Technical Bulletin

Bulletin No.: PRO-01-30

Subject: Compressors for D.D.A.D. Series 60 Engine

This Bulletin has been revised to include additional Tu-Flo 501 and 700 compressor part numbers for the D.D.A.D. Series 60 engine.

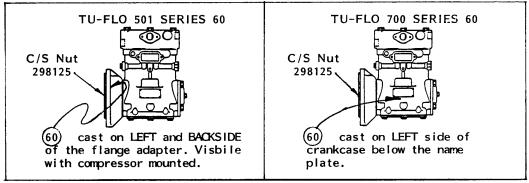
Series 60 Drive Hub Identification - The new Series 60 drive hub 298204 can be distinguished from the standard drive hub by measuring the rear outside diameter.

Series 60 Compressor Identification - Compressors designed for installation on the Series 60 engine CAN BE POSITIVELY IDENTIFIED WITHOUT THE PART NUMBER by the embossed number sixty inside a circle, (60), located on the crankcase or mounting flange. The symbol is approximately 3/4" in diameter.

In addition, the crankshaft drive end of all Series 60 compressors has an M-20x2.5 metric thread and a flanged nut rather than the standard 3/4"-16 English thread and marsden locking nut. The Series 60 flanged nut part number is 298125.

Series 60 Drive Hub Installation - When installing drive hub 298204 on the Series 60 compressor, CRANKSHAFT NUT 298125 MUST BE TORQUED TO 220-254 LB.FT. to properly secure the hub. Depending upon the fit, use either 29 or 30 mm socket. Caution: This torque is for Series 60 compressors only and is more than double the maximum specified for the standard D.D.A.D. crankshaft nuts.
